UNITED STATES PATENT AND TRADEMARK OFFICE

APPLICATION NO.	FILING DATE	FIRST NAMED INVENTOR	ATTORNEY DOCKET NO.	CONFIRMATION NO.
09/766,130	01/19/2001	Lenny Lipton	300.57	9479

Office Action Summary	Application No. 09/766,130	Applicant(s) LIPTON ET AL.	
	Examiner Jennifer T. Nguyen	Art Unit 2629

DETAILED ACTION

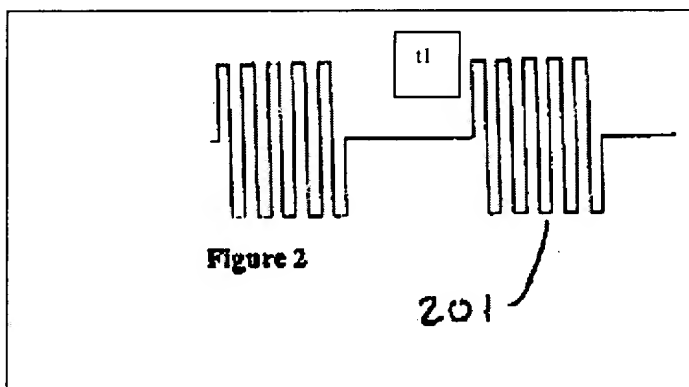
In response to Applicants' argument stated "AAPA and specifically Fig. 2 does not show an alternating unipolar carrier waveform" and "Fig. 2 shows that the waveform does change polarity within the time period that the pi-cell modulator is energized". Examiner respectfully disagrees. Fig. 2 below show that in the time period t1 that the pi-cell modulator is energized, when the cell is active, the waveform has positive polarity within the time period t1; accordingly, fig. 2 show an alternating unipolar carrier waveform within the time period t1.

Applicant also argued that the Office action has no support for the claimed limitation "the small rest period is approximately a few hundred milliseconds". With regard to claims 5, 10, and 15, AAPA fig. 2 show all the subject matter claimed with the exception of the particular ranges

of rest period. However, Absent a showing of criticality it would have been within the level of skill in the art and obvious to one having ordinary skill to design the range of inactive time during the driving time as desired as was judicially recognized in re Rose, 105 USPQ 237 (CCPA 1955) and in re Reven, 156 USPQ 679 (CCPA 1968). Therefore, these claims are rejected for the reason as set forth above.
